Access Compliance Report

Public Rights-of-Way

(Curb Ramps)

Intersection ID: 11985	Main Street: MCGILL_GARDEN_WY	Cross Street: N_DAVIDSON_ST	Location: E
ADA ID: 4AFD86EB00A9	Ramp Type: Directional1	Initial Pass/Fail: Pass	Overall Compliance: No
		Severity Score: 22.5

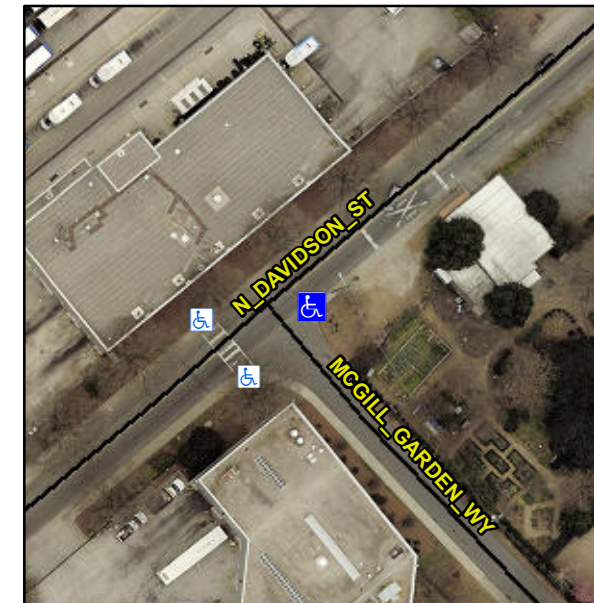
**R304.2.1, R304.5.3, R305.1.4, R305.2,
R302.7, R302.7.2, R304.5.4**

**Remove & Replace Entire Ramp.
Remove & Replace Gutter.**
